MEMORANDUM

To: Salt Lake City Historic Landmark Commission

Date: May 3, 2018

Re: Liberty Square Apartments PLNHLC2017-00266 & PLNHLC2015-00237

SITE PLAN

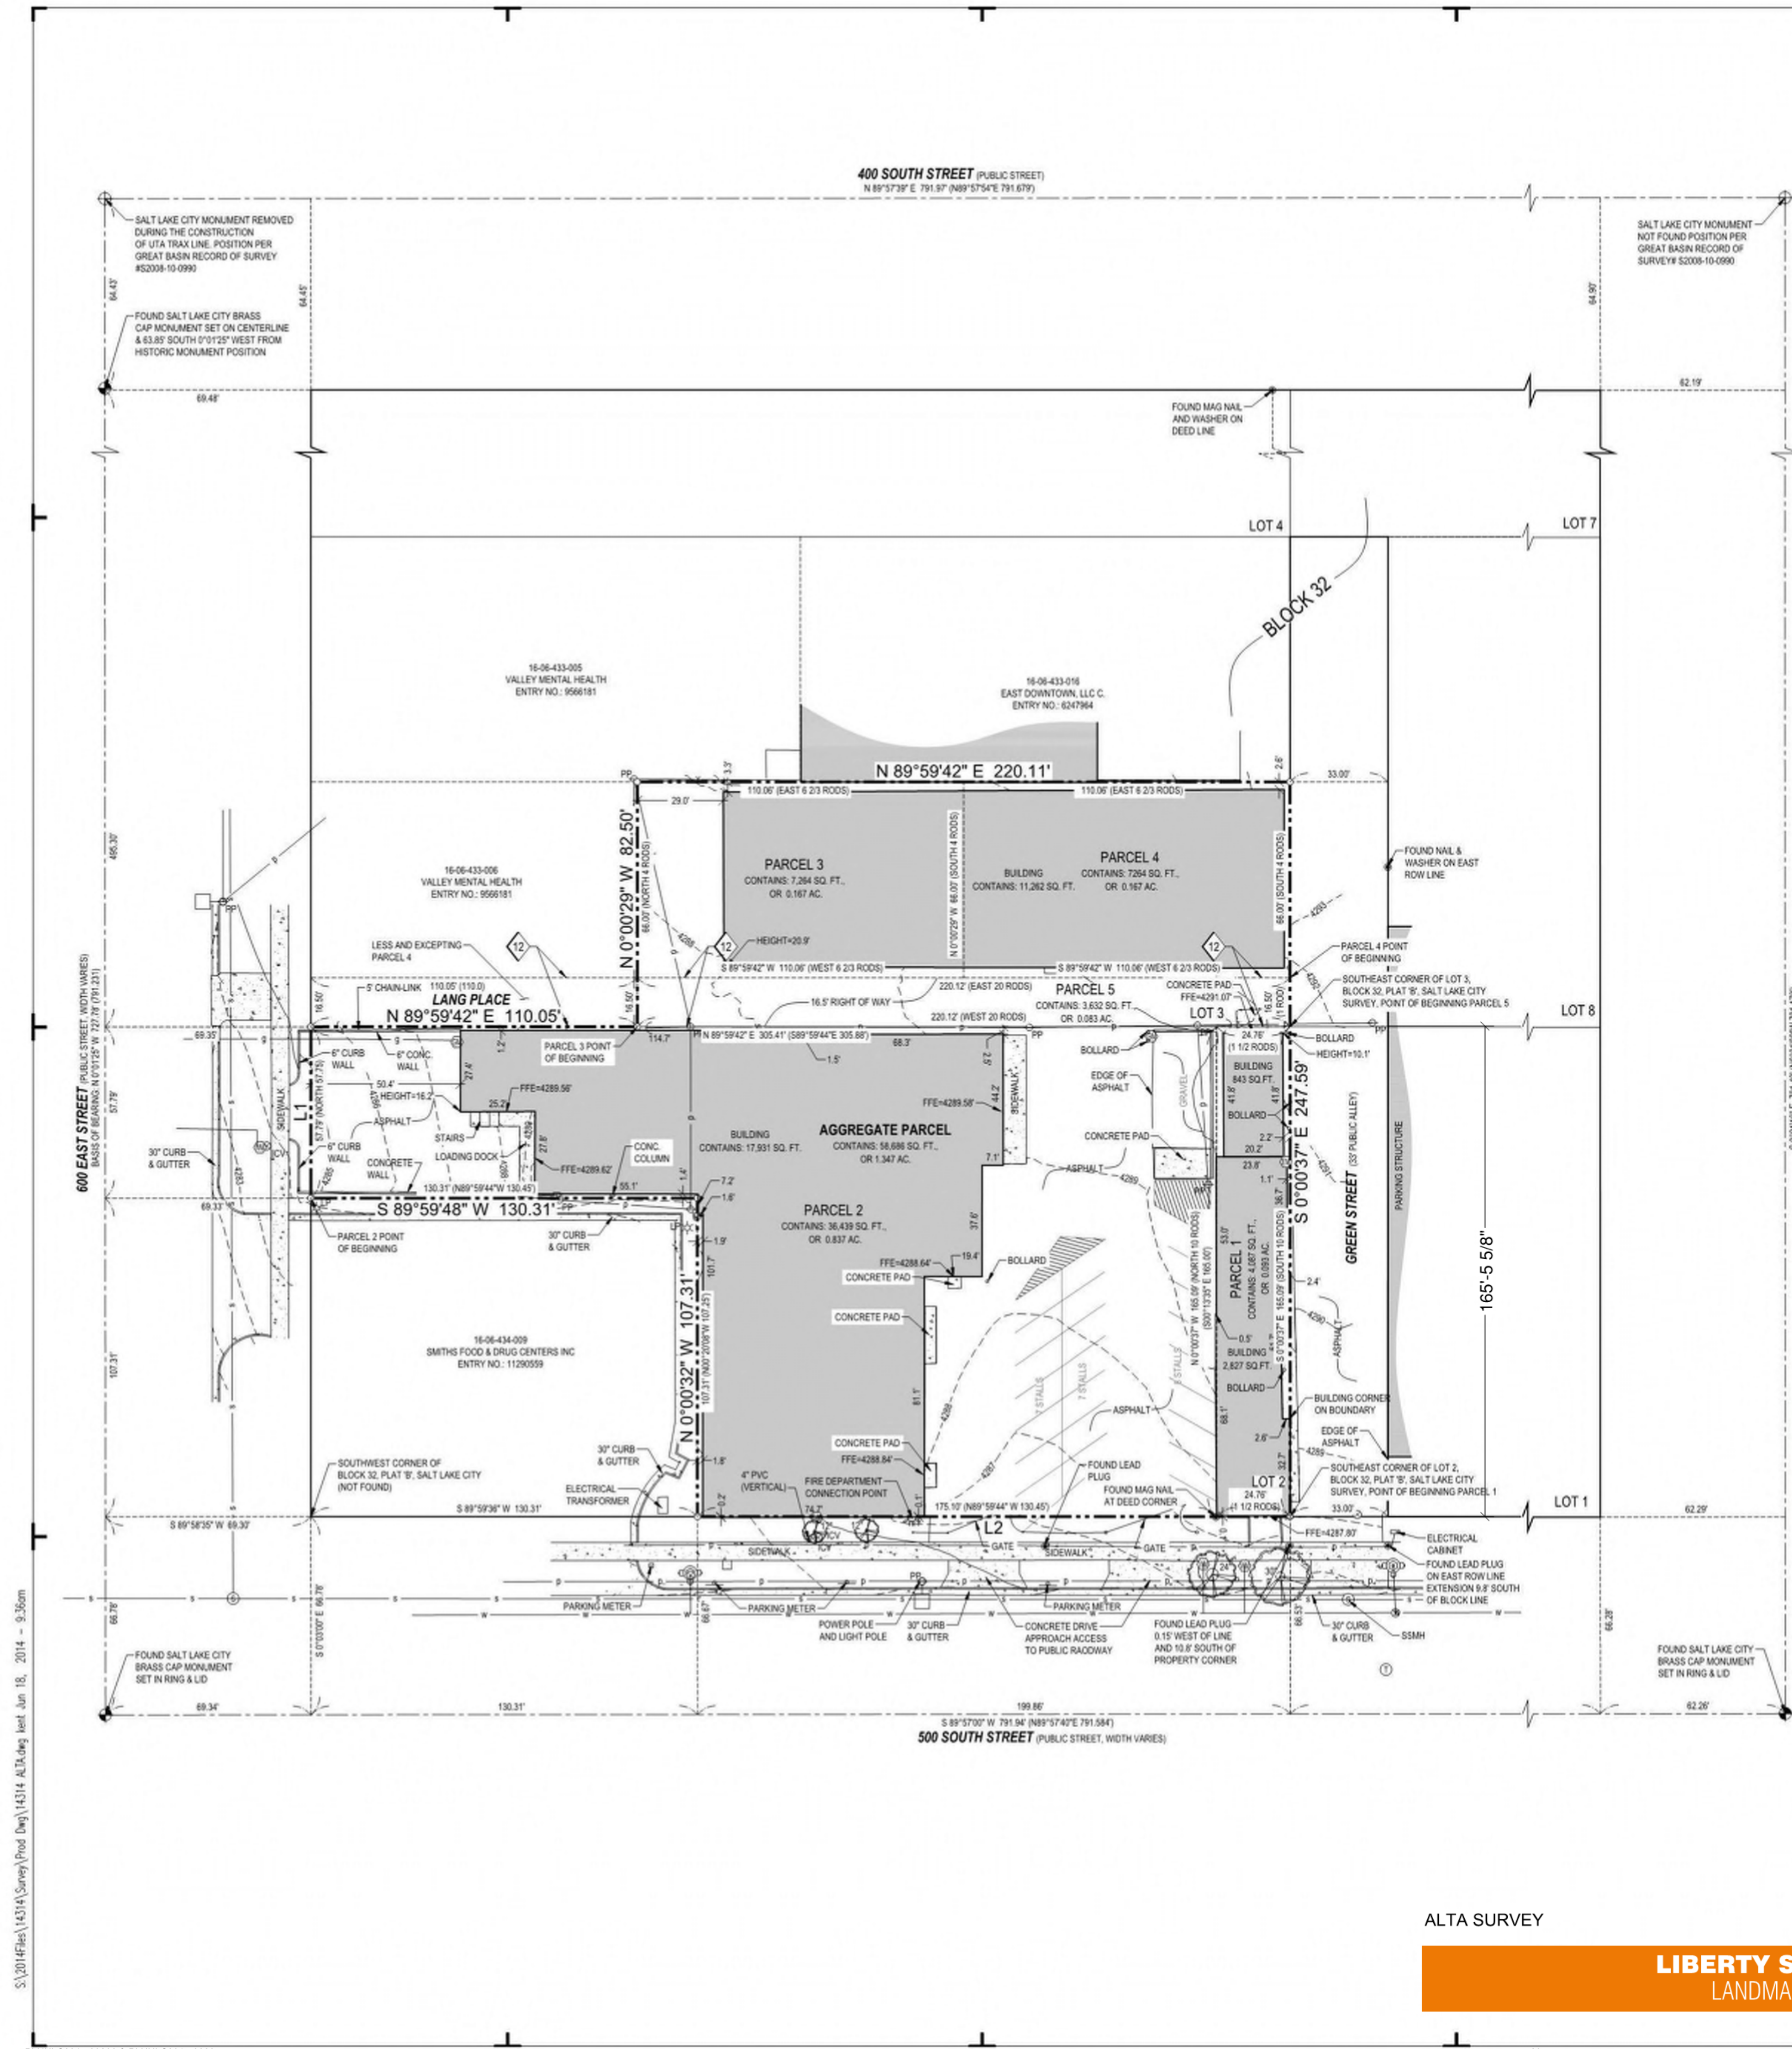
Previously Approved: Illustration 1 highlights the approved site layout for Liberty Square. Building 1 framed 500 South, while Buildings 2 and 5 framed 600 East. The additional buildings were placed to create interior courtyards, for example: Buildings 3 and 4, as well as Building 6 and 7 were sited with the primary elevations facing the interior courtyards.

Changes to the Approval: The architect moved Building 4 to face Green Street, Building 3 further east, portions of Building 2 were moved closer to the west and a unit from Building 3 was moved to Building 8.

Reason for the Change: The changes to the approved site plan were primarily caused by challenges with the required fire code, specifically the aerial fire apparatus access roadway requirements.

Staff Recommendation: Staff supports these changes. The movement of the guest parking to the interior of the site and the re-arrangement of Building 4, both create additional pedestrian interest and integration of the development with the public way.

SHEET NO. **A0.1**

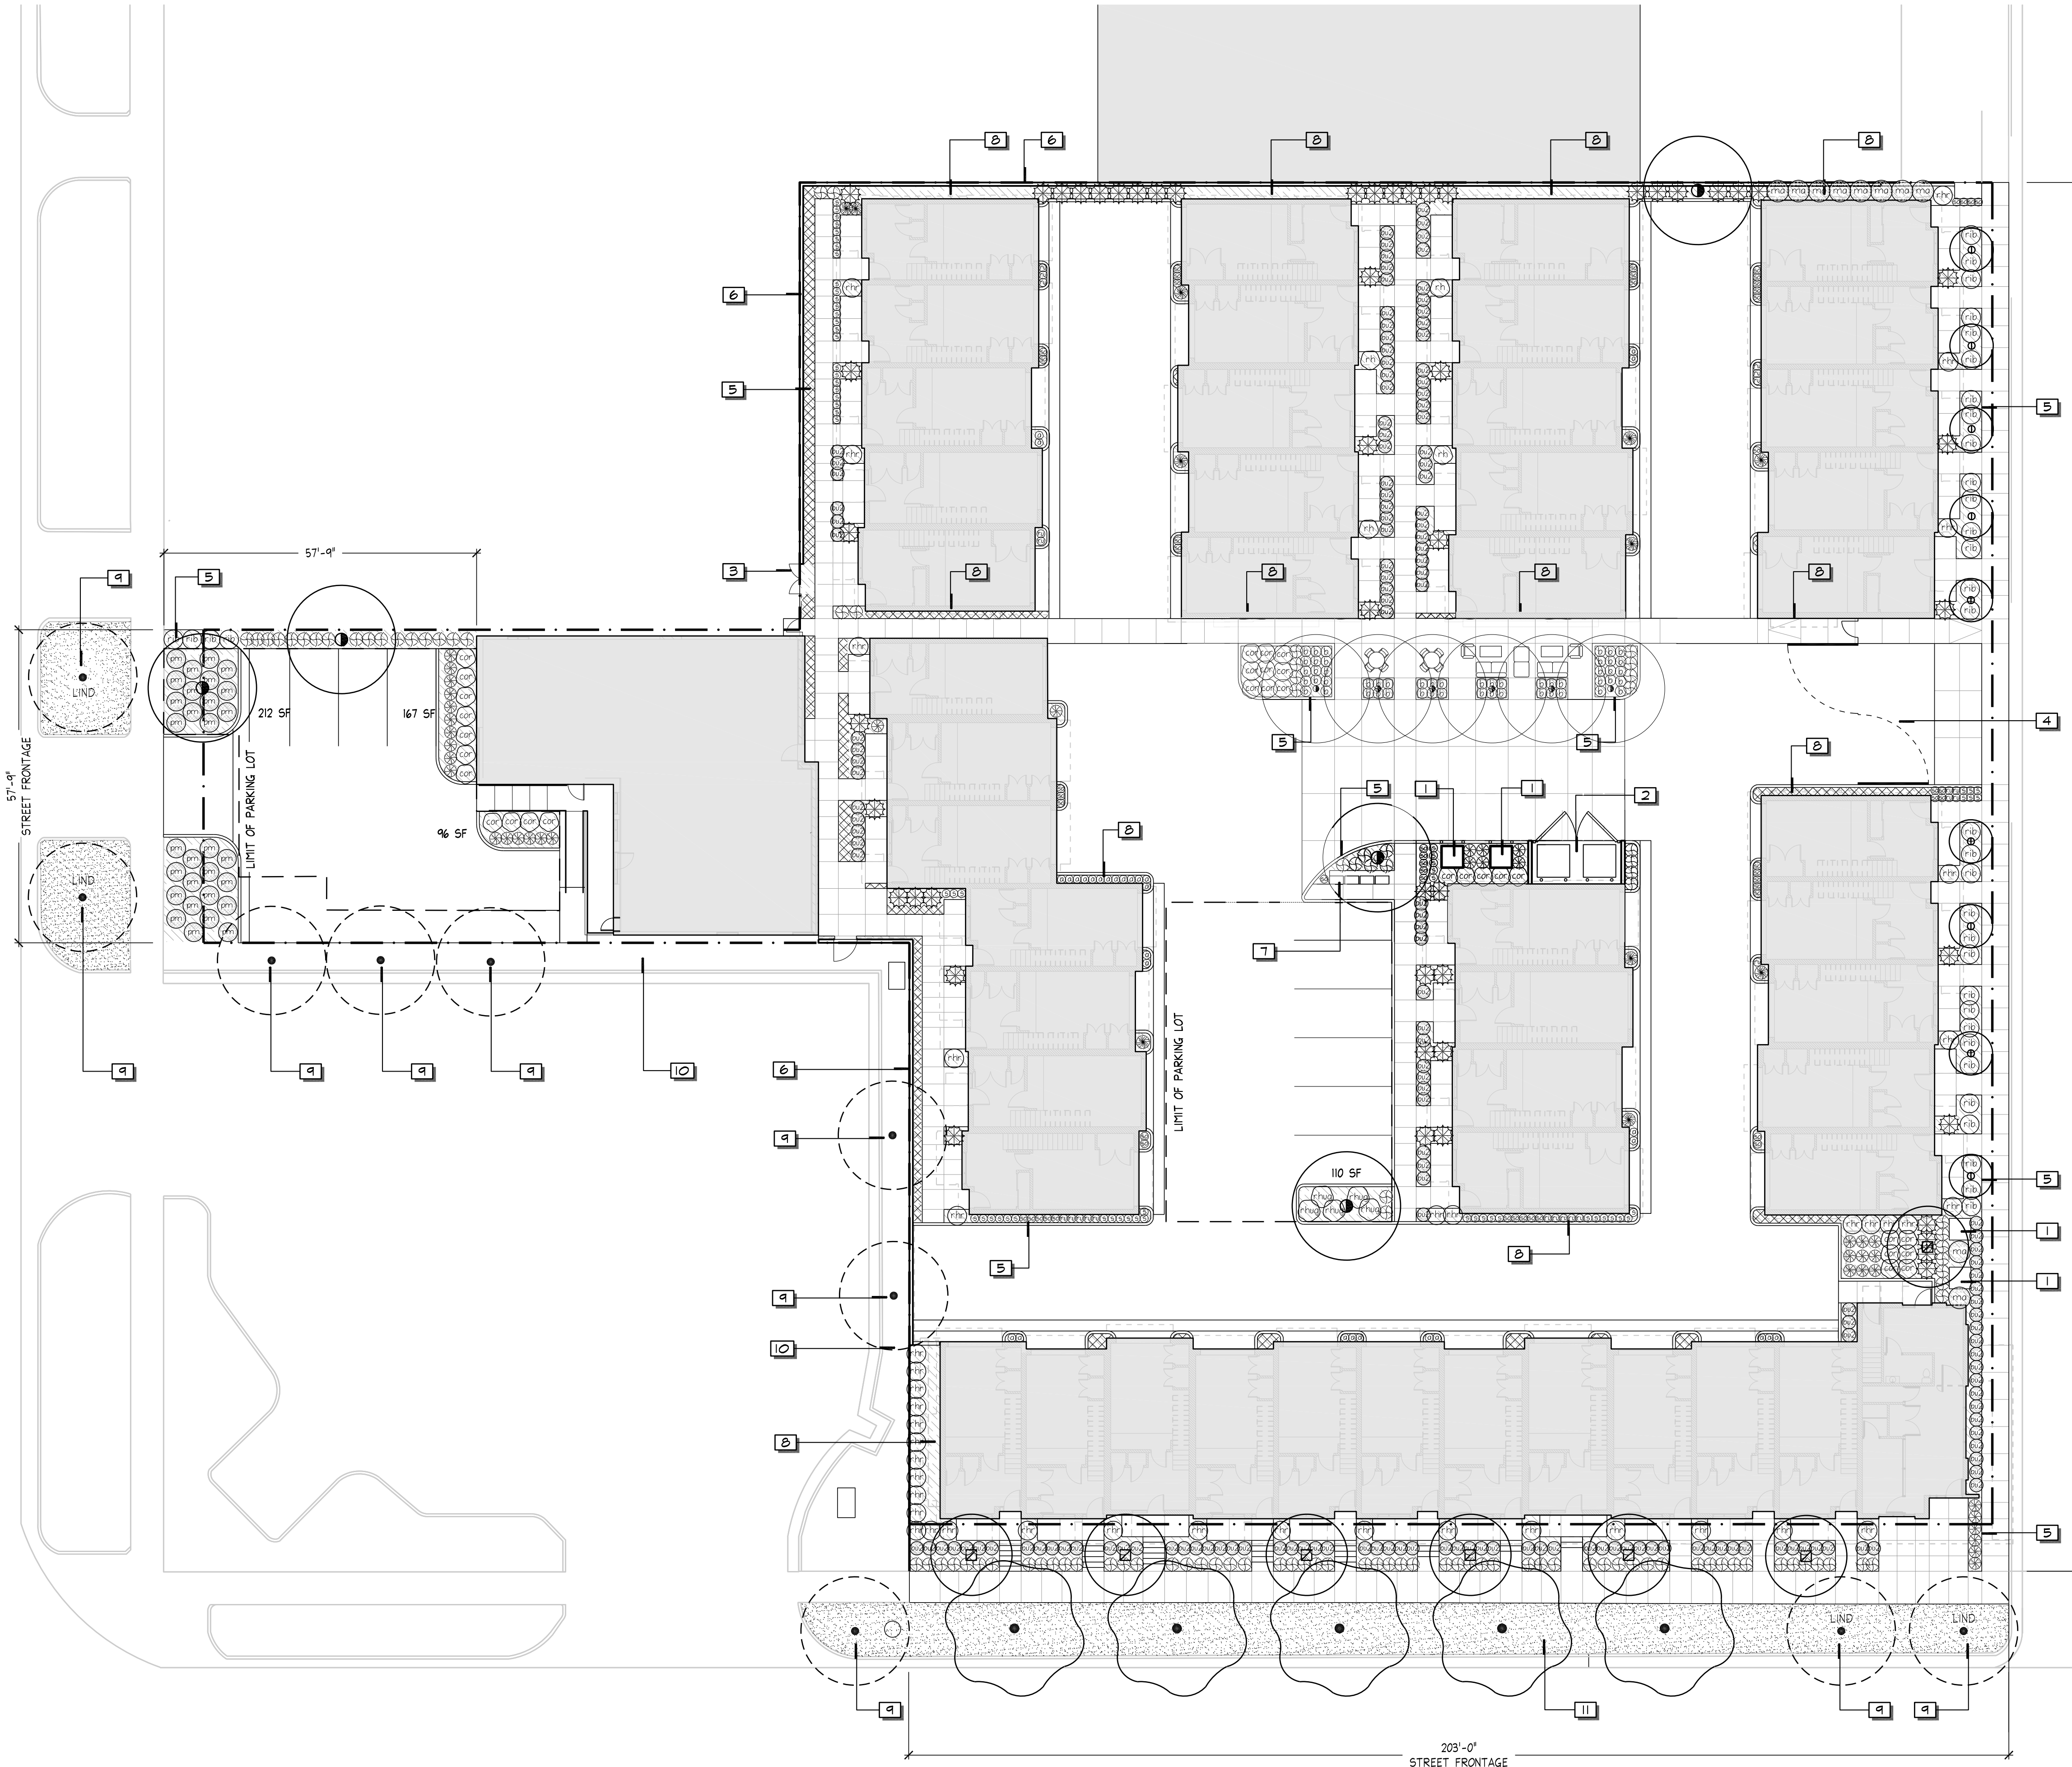
From our discussions with the Salt Lake City Fire Department, and as later reviewed with you and Chris Zarek, Buildings 3 and 4 have been relocated further to the east, placed along the west edge of Green Street, to accommodate an aerial fire apparatus access roadway complying with Section D105 of the 2015 International Fire Code (IFC). With Buildings 3 and 4 complying with the provisions for an aerial fire apparatus access, the respective buildings are allowed to be constructed greater than 30-feet in height as originally planned in the June 2017 HLC submittal. This revision moves the parking that was oriented along Green Street to the interior of the project and allows for Building 4 to be located on and directly face Green Street providing a stronger presence from the south east corner of the project as well as screening the parking from Green Street.

As part of accommodating the required roadway, the north unit of Building 3 has been relocated to the north end of Building 8, and the trash enclosure was relocated within the site, away from the public view along the north side of Building 3. As a result, the trash enclosure is proposed to be provided as a masonry enclosure matching the north masonry base of Building 3 as shown, in effort to provide a more discrete trash enclosure.

The central landscaping was revised from its location at the center of the drive aisle to the south end of Buildings 6 & 7 to accommodate the 41-foot clear fire aerial apparatus access required by the fire department. This area has been designed to create a common exterior courtyard for the use of the tenants. Refer to the attached Site Plan drawing A0.1 and Partial Landscaping Plan.
